Q657NAS1

# TECHNICAL BULLETIN

Service Action: Engine Ground Fixing Loose - Diesel V6

3

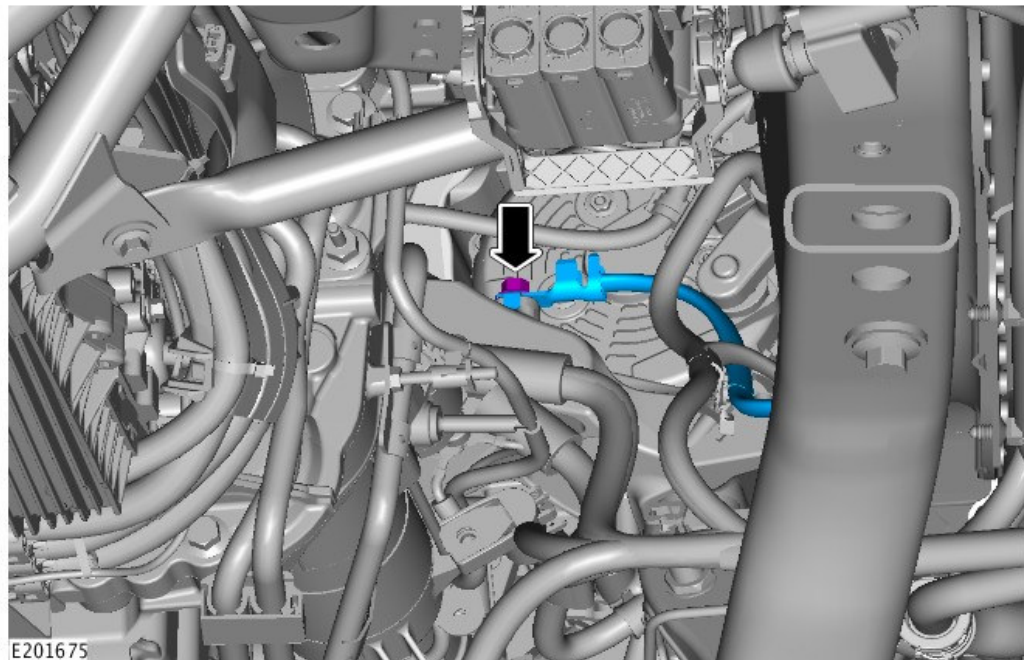
An issue has been identified on certain vehicles within the listed Affected Vehicle Range may have been manufactured away from process and the engine ground fastener located on the transmission may not have been clamped in line with the design intent. This may lead to a possible non-start concern being experienced.

Using a suitable tool, tighten the ground fixing.

Torque: **24 Nm** .
